### REMARKS

In the office action mailed April 26, 2005 (the "Office Action"), the Examiner objected to the drawings and further objected to claims 1, 4, 9, and 13-16, based on informalities. The Examiner also rejected claims 1-22 under 35 U.S.C. 112, second paragraph.

Amendments to the Drawings:

*Fig. 3*  
(Background Art)

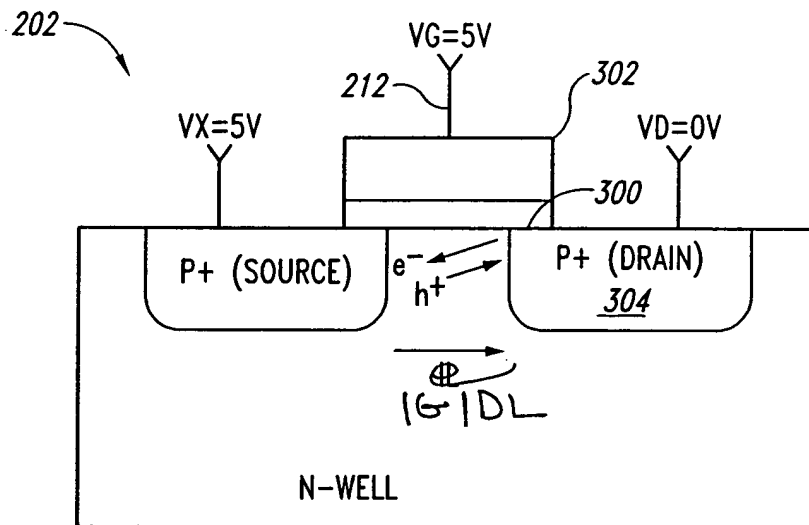
Figure 3 has been amended so that the gate-induced drain leakage is labeled in Figure 3 as "IGIDL".

*Fig. 4*

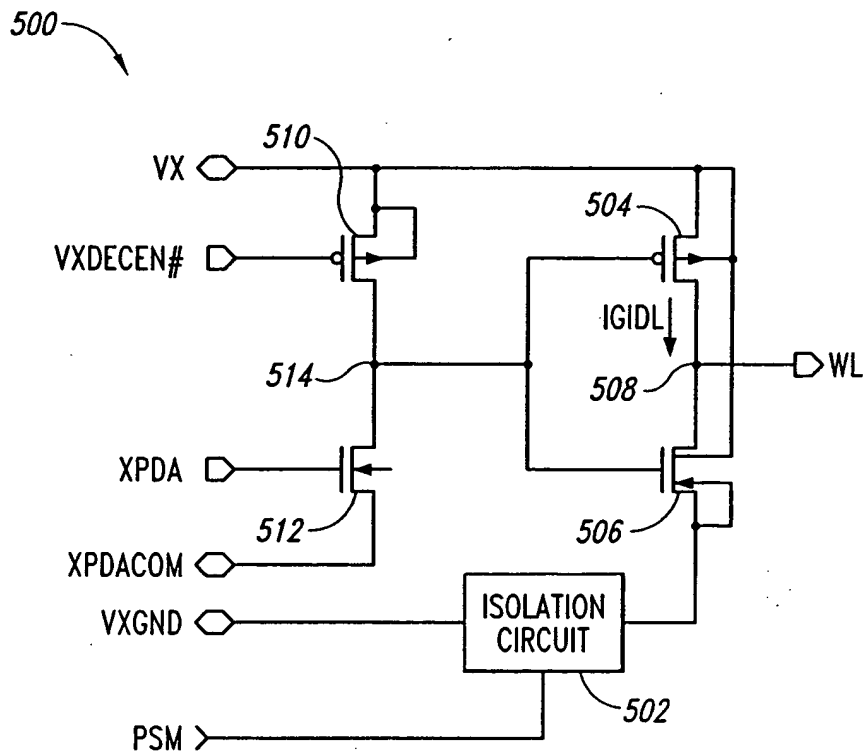
With respect to the Examiner's objections to the drawings, Figures 3 and 5 have been amended as suggested by the Examiner. Additionally, the specification has been amended to remove reference to the "discharge controller 300." As for the Examiner's objection to the drawings for failing to show "an input signal" and "a test signal," Figure 4 illustrates an input signal and a test signal. In the embodiment illustrated in Figure 4, the input signal is generated at the node 514 by the PMOS and NMOS transistors 510, 512. The input signal at the node 514 has a HIGH logic level in response to the VXDECEN# and XPDA signals having LOW logic levels. Conversely, when the VCDECEN# and XPDA signals have HIGH logic levels, the input signal at the node 514 has a LOW logic level. Operation of the row driver 500 in response to the input signal at the node 514 and the VXDECEN# and XPDA signals is described at page 7, line 23-page 8, line 17. In the embodiment of the row driver shown in Figure 4, the test signal corresponds to the PSM signal that is provided to the isolation circuit 502. As described in the present application, the PSM signal indicates whether a flash memory is operating in a normal mode or in a power-savings mode. See page 7, lines 20-21. Operation of row driver 500 with respect to the PSM signal is described at page 7, line 23-page 8, line 17. Thus, both "an input signal" and "a test signal" are shown in Figure 4. For the foregoing reasons, the Examiner's objections to the drawings should now be withdrawn.

Fig. 5

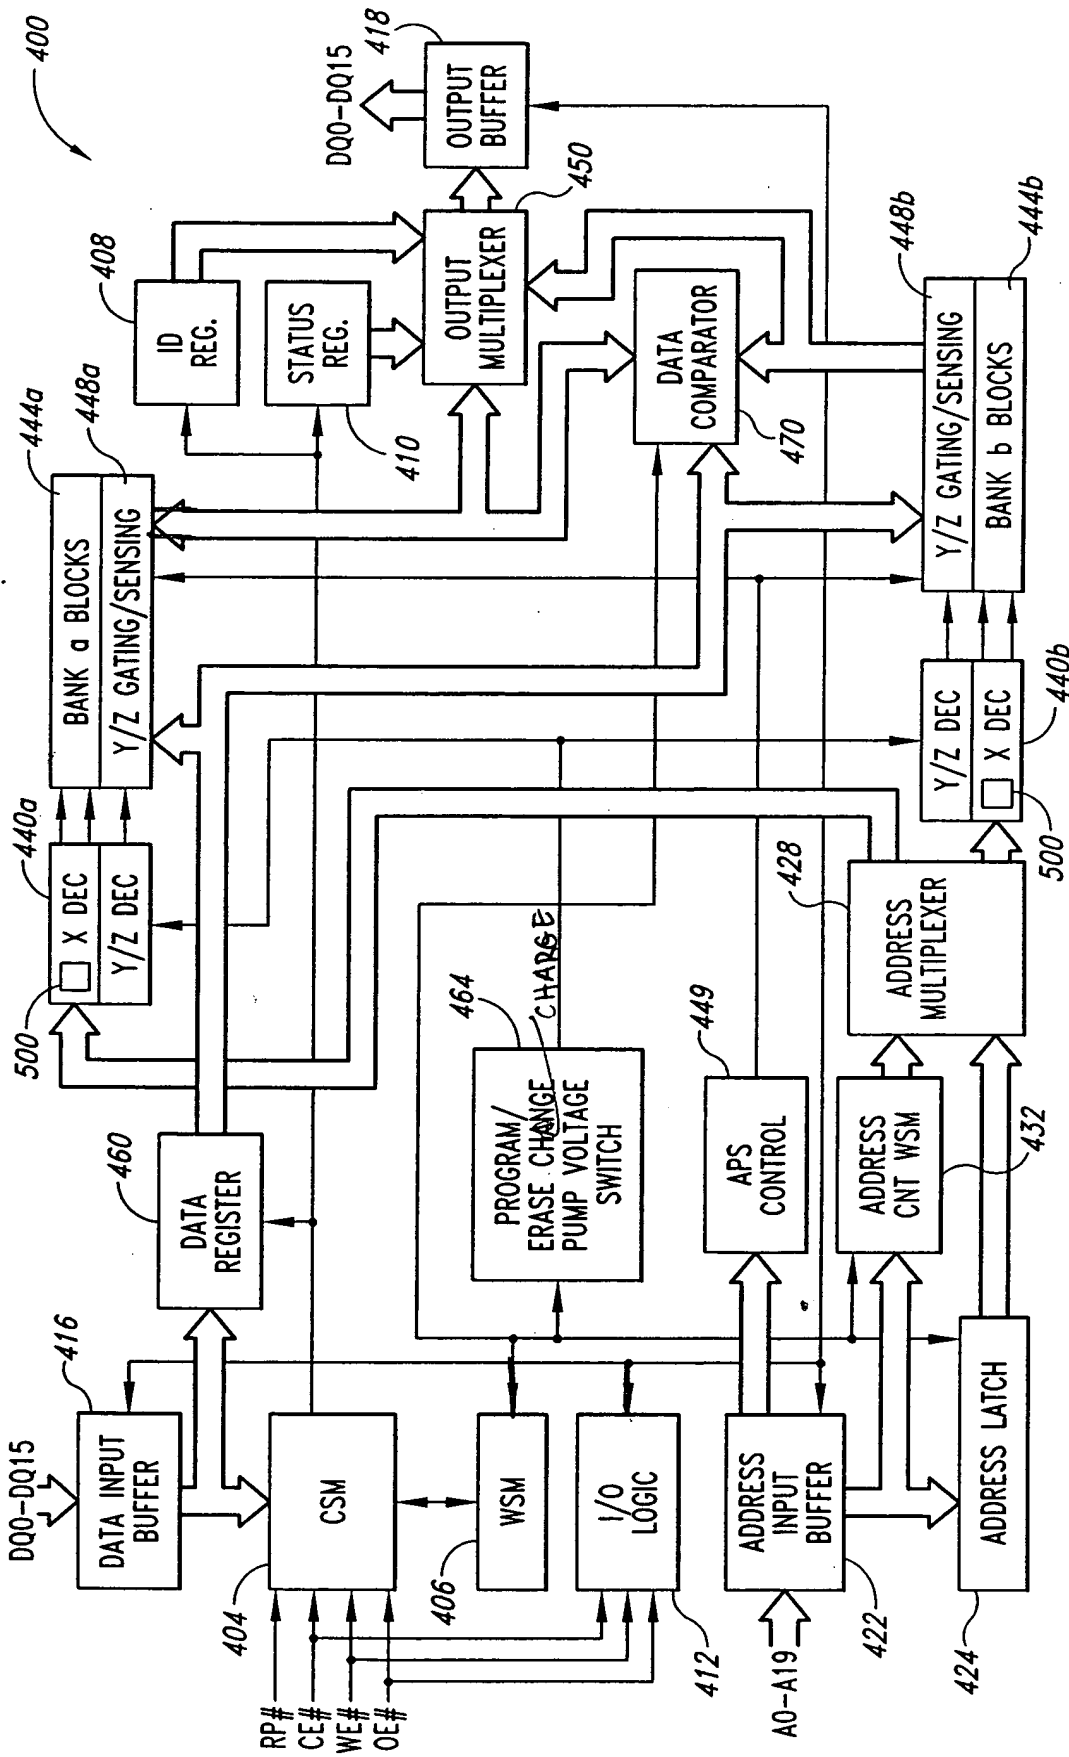
Figure 5 has been amended to correct a typographical error in circuit block 464, to remove an arrow pointing to WSM 406, to remove an arrow pointing to the I/O Logic 412, and to remove "the third arrow pointing to the right bottom side of circuit block 448a".
